Subject: RATTLING NOISE FROM SECOND SEAT UNDER VARIOUS VEHICLE SPEEDS AND ROAD CONDITIONS	Bulletin No.: 09-017/26
	Last Issued : 08/11/2026

Previous TSBs:	Date(s) Issued:
09-017/26	05/20/26

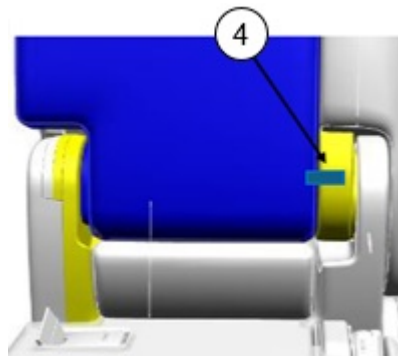
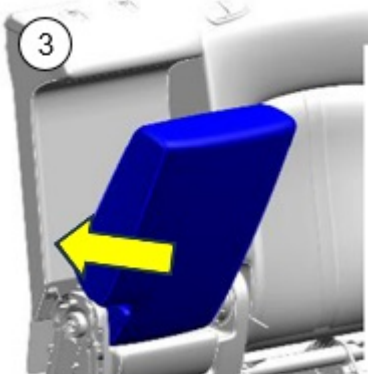
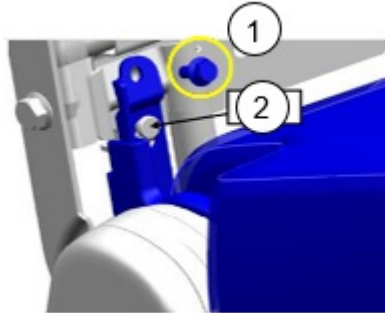
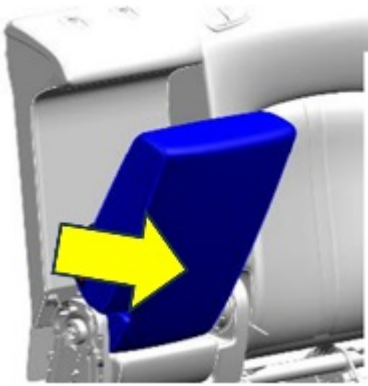
Some customers may complain that a rattling noise is heard from the second seat while driving under various vehicle speeds and road conditions. This is caused by the hinge cover of the second seat becoming deformed, resulting in looseness and a rattling noise.

To eliminate this concern, the structure of the second seat hinge cover was revised to increase strength and prevent deformation.
